CITY OF PATASKALA BOARD OF ZONING APPEALS

STAFF REPORT

Conditional Use Application CU-20-004

Express Car Wash Conditional Use Review

SITE PLAN
1" = 20'-0"

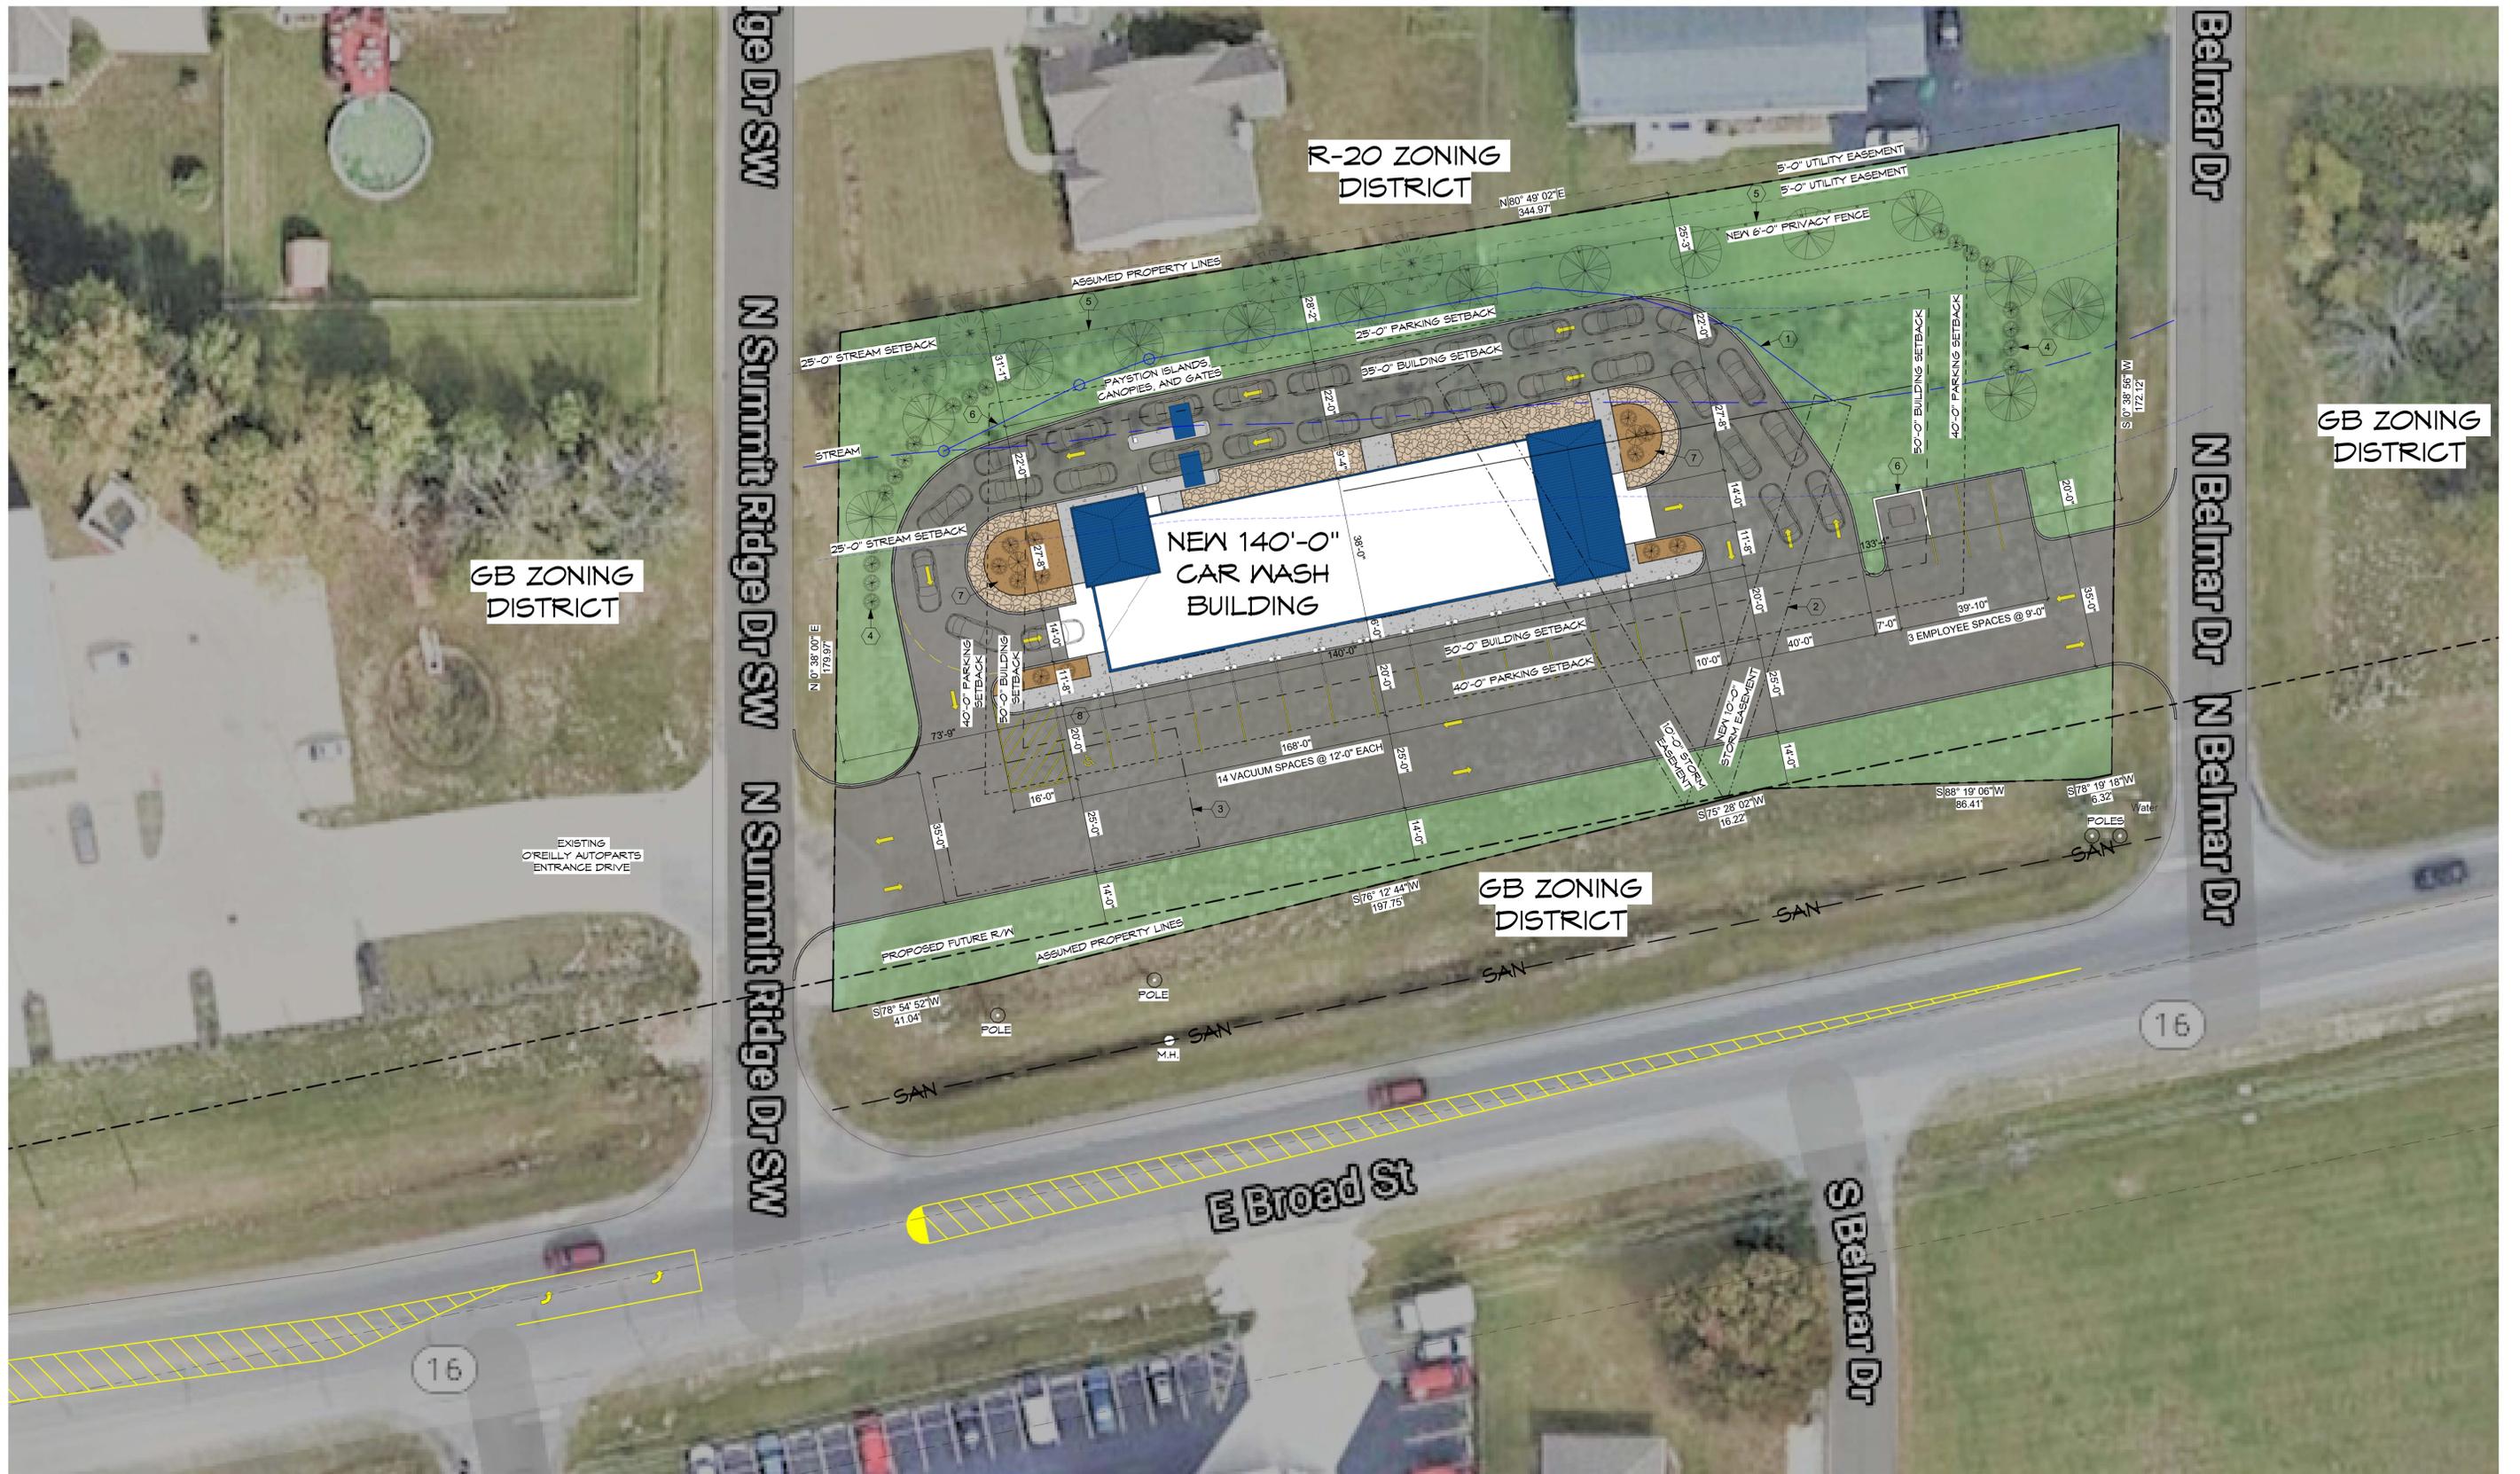
- a. The right-of-way line shall be straightened to parallel the roadway as shown in the site plan.
- b. Relocation of storm water easement facilities to be coordinated during engineering.
- c. As indicated in the site plan, a left-turn lane shall be installed on Broad Street to satisfy the requirements of the TCOD. Final details to be determined during engineering.
- d. Piping-in the creek shall be permitted by the appropriate authority having jurisdiction, either the EPA or ACOE, and shall also be coordinated with the City of Pataskala.

- a. Relocation of storm water easement and facilities to be coordinated during engineering
 - i. The layout shall ensure the outfall is with the flow of the channel and not against it.
 - ii. Storm Easement width should be increased to 20'

- Applicant has provided a screened area of a dumpster, however the height of the proposed screening was not provided. Per Section 1283.06(13)(b): the average height shall be one (1) foot more than the height of the dumpster, but no more than 10-feet.

- 9'4" on the north side, however only 6' on the south side of building.

- Access drives shall be a minimum width of 28 feet for two-way traffic, and a minimum width of 14 feet for one-way traffic
 - Proposed distance of access drive off N Belmar Drive is 35 feet, which is compliant. Is this the same distance from N Summit Ridge Drive? Indicate on plans.

- 1291.07(B): Dimensions shall be 11 feet wide, 19 feet deep. 5-foot wide access aisle on at least one side.
 - Length appears to be ok, width not indicated. Also need that 5-foot wide access aisle on one side with a ramp up to the sidewalk with a slope not to exceed 1:20, or as indicated by the ADA guidelines.
 - Signage for the accessible space must also be provided, details in 1291.07(C).
 - Applicant provided 12'x20' ADA space with a 16' access aisle on one side.
